TECHNICAL MEMO

To Linda Riley
From Biljana Rajlic
Date March 13, 2012
Project # 285380
Reference Tunnel watertightness
Page 1 of 16
CC

PART 1 – ORIGINAL TUNNEL WATERTIGHTNESS MEMO (REV A)

PART 2 – RESPONSE TO HMQ COMMENTS (SEE APPENDIX)

Figure 5 – Drains in a typical WEP tunnel abutment (extract from Structures design submission)

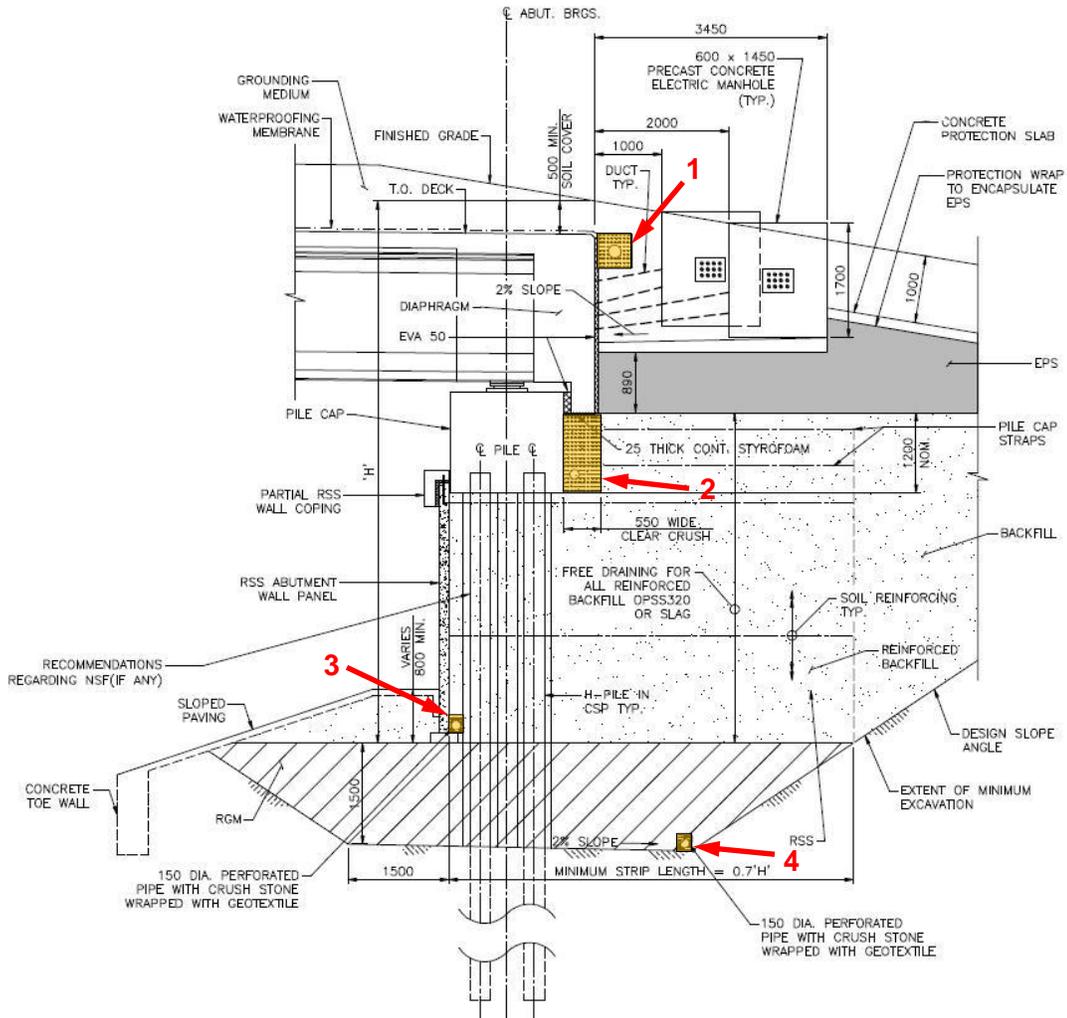
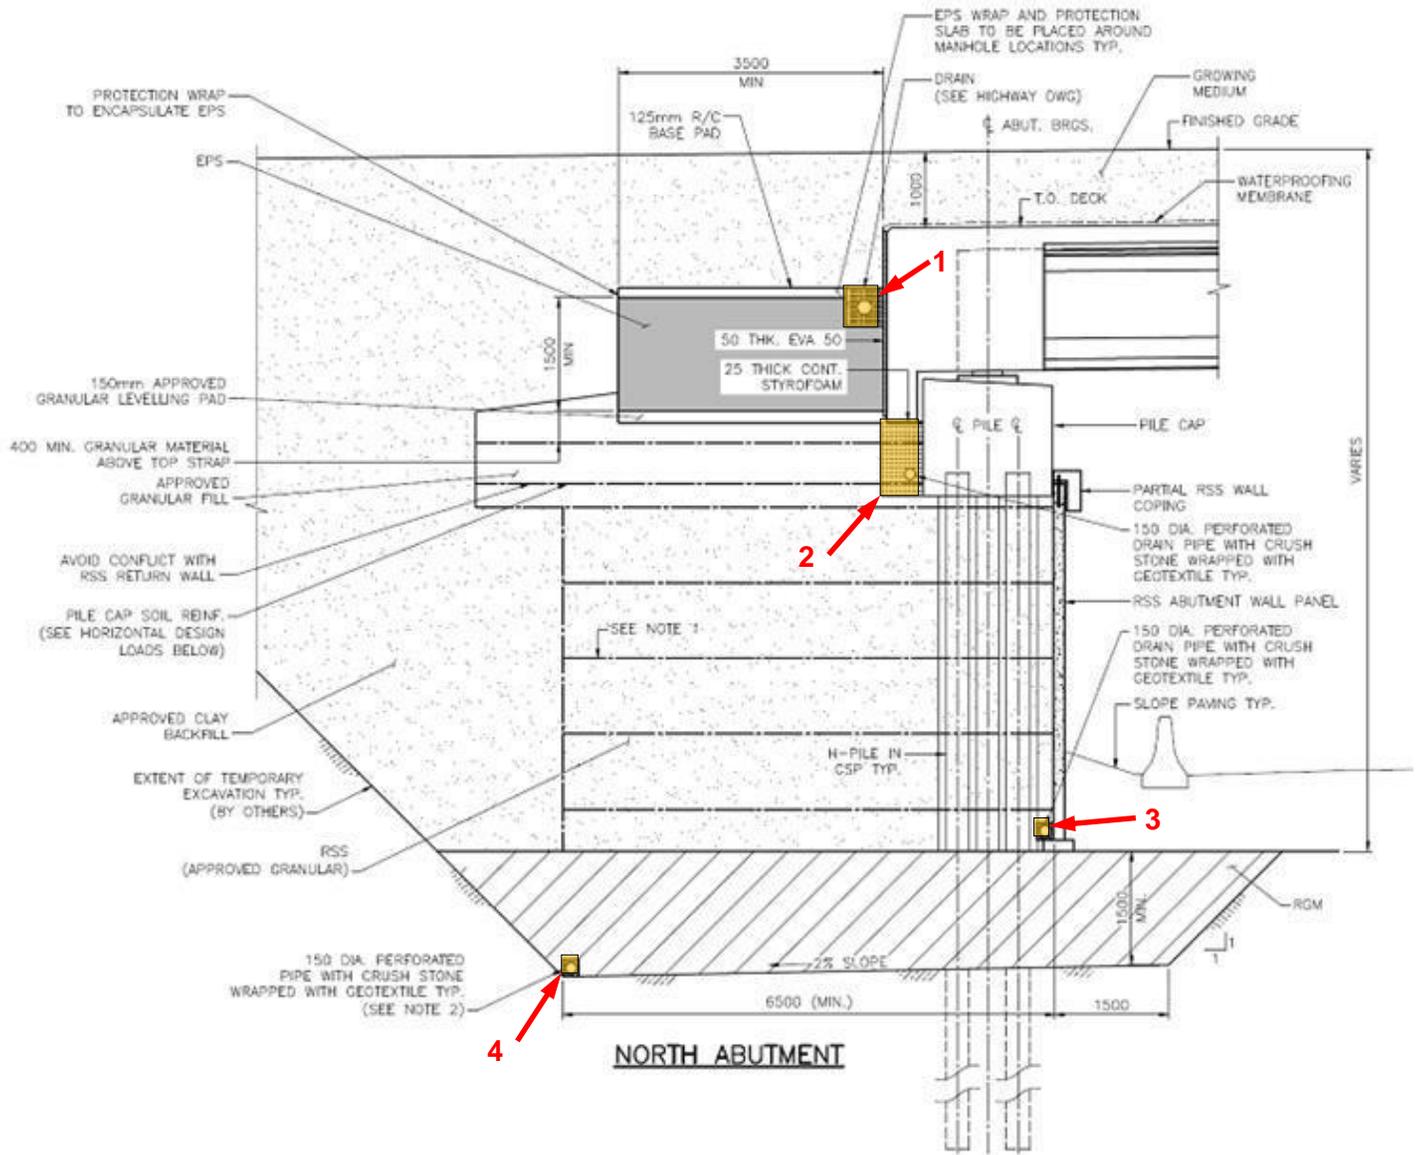
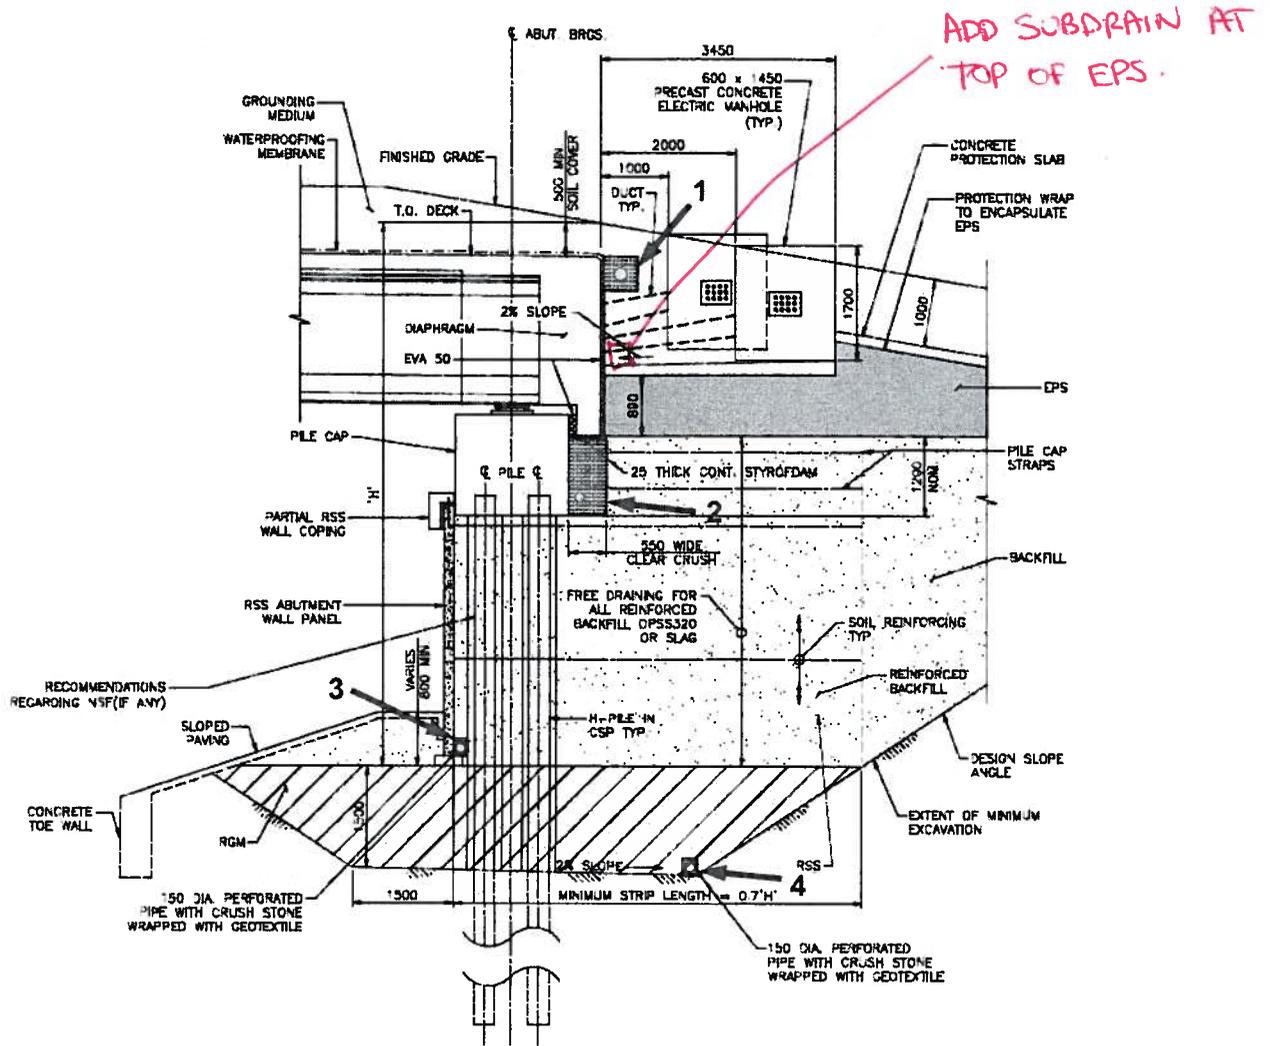
AECOM comment: "...It is suggested that a fifth subdrain be provided at the top of the EPS, directly behind the abutment cap. Refer to the enclosed Figure 1 markup. This additional subdrain is warranted because the EPS could act as an impervious layer, preventing water from migrating down to subdrain #2."

- 2) With respect to the four (4) lines of subdrains identified in Section 4 of WEMG's letter, it is suggested that a fifth subdrain be provided at the top of the EPS, directly behind the abutment cap. Refer to the enclosed Figure 1 markup. This additional subdrain is warranted because the EPS could act as an impervious layer, preventing water from migrating down to subdrain #2.

Since the issue of revision A of this memo, the precast concrete manholes removed from this location. A typical section is now as shown in Figure 5 below. It can be seen that there is no need for the suggested fifth subdrain.

Figure 6: Typical cleanout details (extract from Highways design submission)

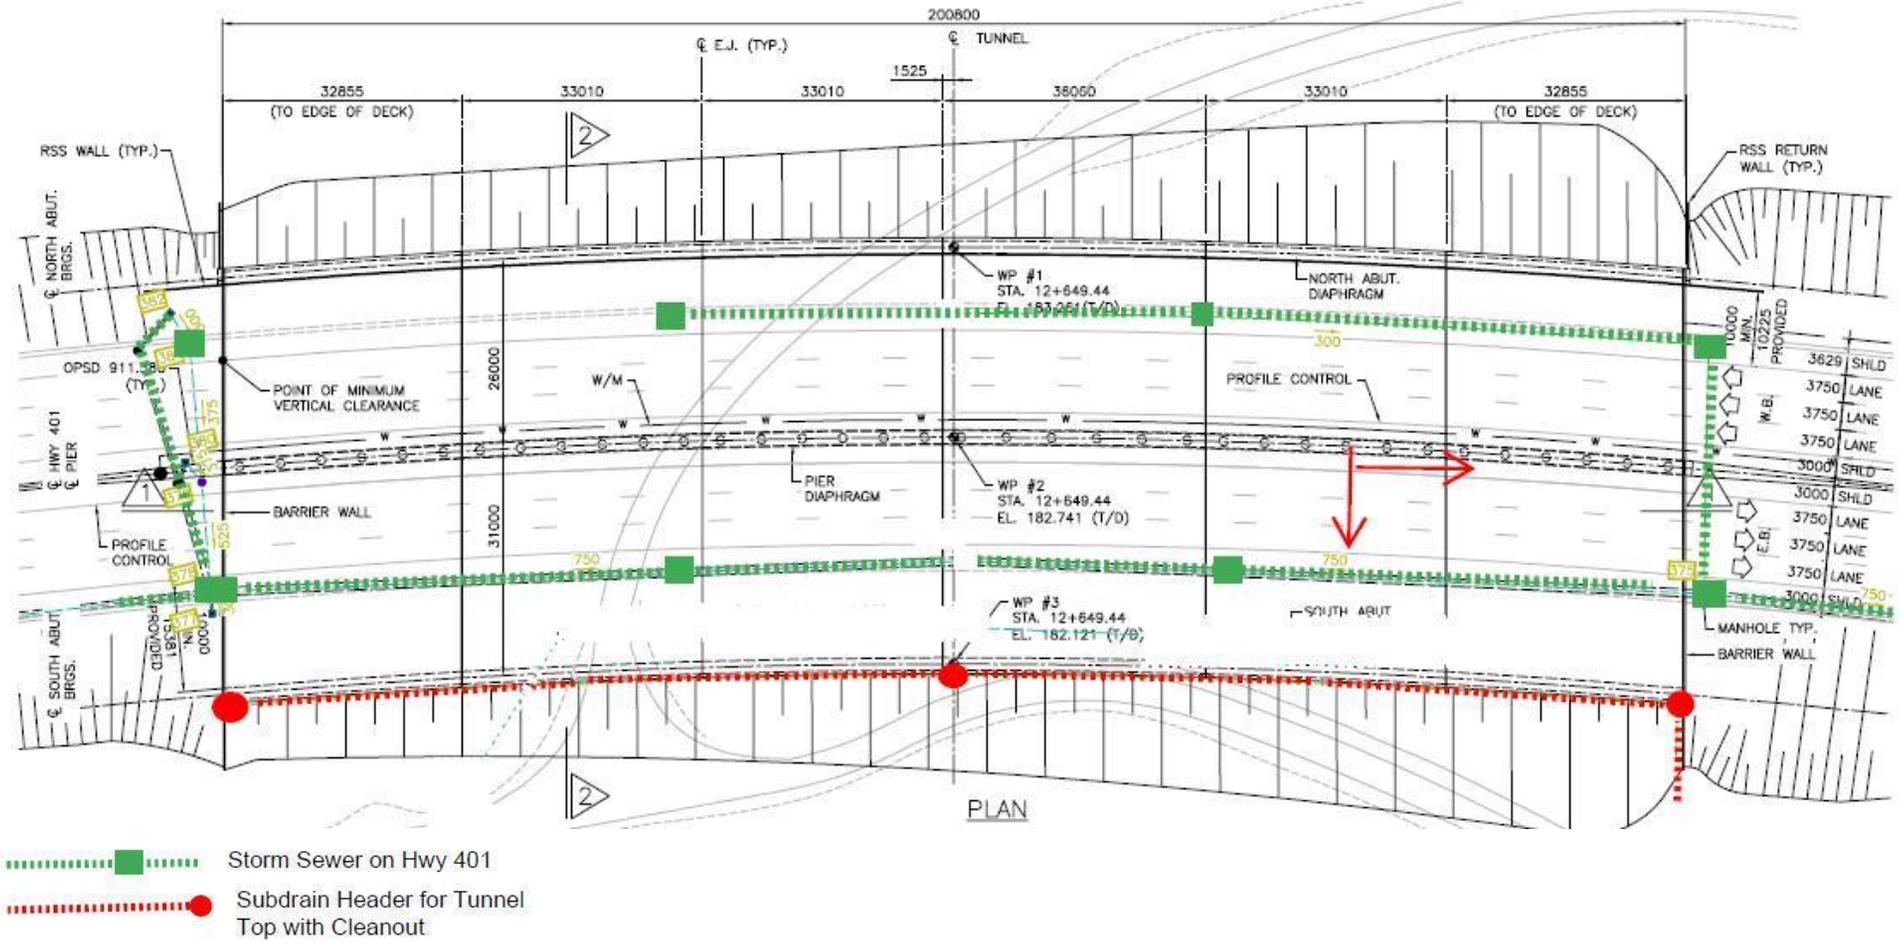
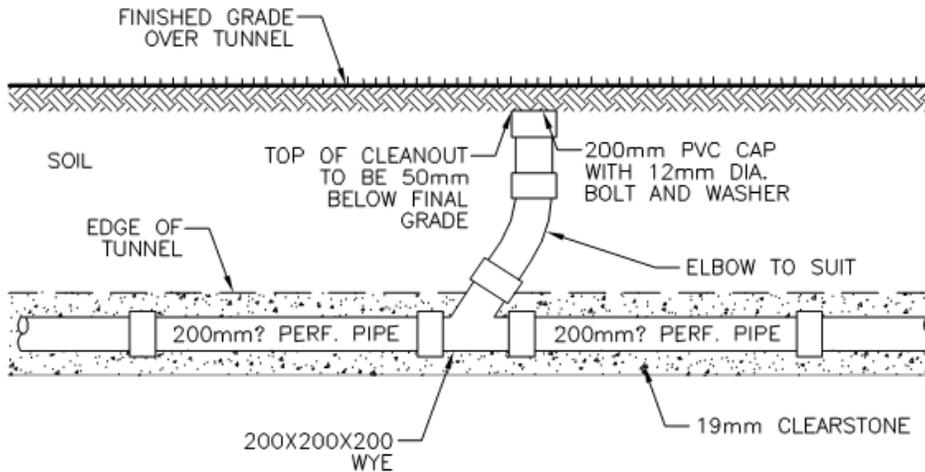
AECOM comment: "...As each of the 5 lines of subdrains has a specific purpose for the drainage of a specific area of the structure, the subdrain system may not provide sufficient redundancy in the event that one or more pipes become blocked. WEMG should propose a means of monitoring the performance of the subdrain system and removing any plugs. Further detail should also be provided for the "Cleanouts" shown in Figure 3."

- 4) With respect to the 5th paragraph in Section 4 of WEMG's letter, the term 'well-graded material' infers some percentage of fines, which can clog the subdrains. As each of the 5 lines of subdrains has a specific purpose for the drainage of a specific area of the structure, the subdrain system may not provide sufficient redundancy in the event that one or more pipes become blocked. WEMG should propose a means of monitoring the performance of the subdrain system and removing any plugs. Further detail should also be provided for the "Cleanouts" shown in Figure 3.

WEMG is of the opinion that the subdrain system will provide sufficient redundancy in the event that one or more pipes become blocked. The system is to be installed according to the requirements of OPSS 405, and the subdrains will have sufficient slope for the water to drain properly.

Inspection of the subdrains will be part of the detailed structures inspection that is specified to happen every year. Any blockages should be minimal but will be identified through the normal inspection process.

Further detail for the "Cleanouts" has now been provided in the Highways design submissions. Typical details are shown in Figure 6.

Figure 7: Abutment joint seal (extract from Structures design submission)

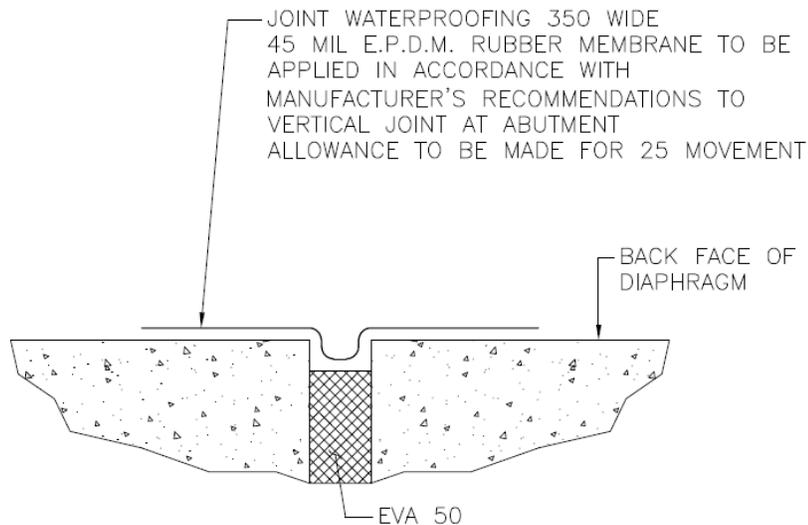
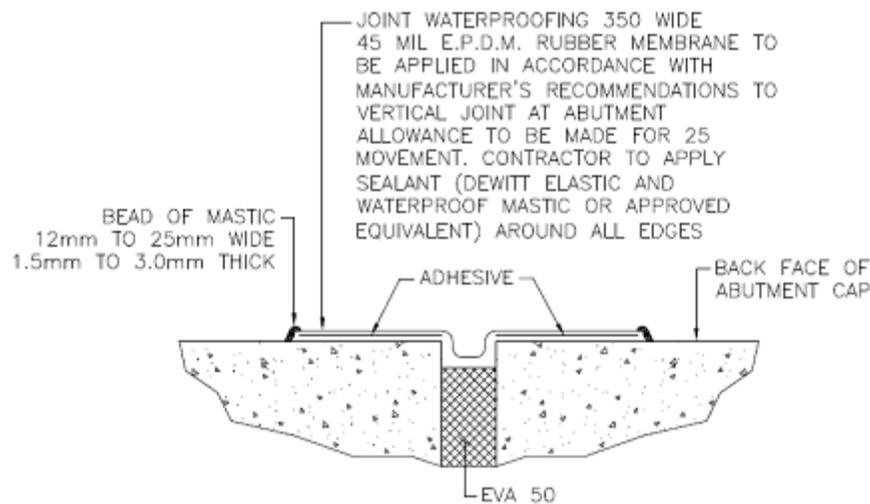
AECOM comment: "...the edges of the rubber membrane should be sealed to prevent the ingress of water between the concrete and the membrane."

- 5) The proposed details at abutment joints referenced in Section 5 of WEMG's letter are in general conformance with OPSD 3950.100, November 2011. Evafoam has been substituted for the fibreboard filler specified in the OPSD, which is an improvement. The only comment to be directed to WEMG with respect to the abutment joints is that the edges of the rubber

membrane should be sealed to prevent the ingress of water between the concrete and the membrane.

WEMG fully agrees with this comment, and Tunnel drawings will specify that the rubber membrane be fully sealed to the concrete surface with an appropriate adhesive system around all edges, as shown in Figure 7.
